Proposal for Supplement 7 to the 03 series of amendments to UN Regulation No. 95 (Lateral collision)

The text reproduced below was prepared by the experts from OICA. It proposes some slight modifications to the proposal submitted by the expert from Germany and reproduced in document ECE/TRANS/WP.29/GRSP/2017/40

Figure

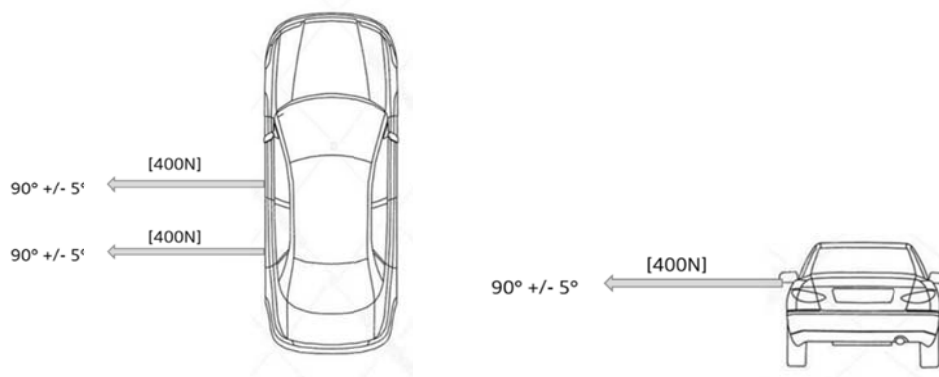
Document ECE/TRANS/WP.29/GRSP/2017/40, Paragraph 5.3.1., replace by (rest of the proposal remains unchanged):

"5.3.1. No door shall open during the test.

This requirement is deemed to be fulfilled:

- (a) if it is clearly visible, that the door lock is latched; or
- (b) if the door does not open under a force of at least [400 N] in the y-direction applied to the door, according to the Figure below, as close as possible to the window sill and to the edge of the door opposite to the hinged side, except to the door handle itself."

While generally agreeing with the aim of the German proposal GRSP/2017/40, OICA considers it necessary to better specify the test procedure in order to avoid different interpretations among the Technical Services. (The attached pictures are further explaining the procedure)

OICA also proposes to slightly reduce the suggested force level, since according to test engineers, applying a force of 500 N on a slippery test floor might be difficult to achieve. Also, the traction device/clamp might tear loose creating a safety risk if the force level is maintained at 500 N.
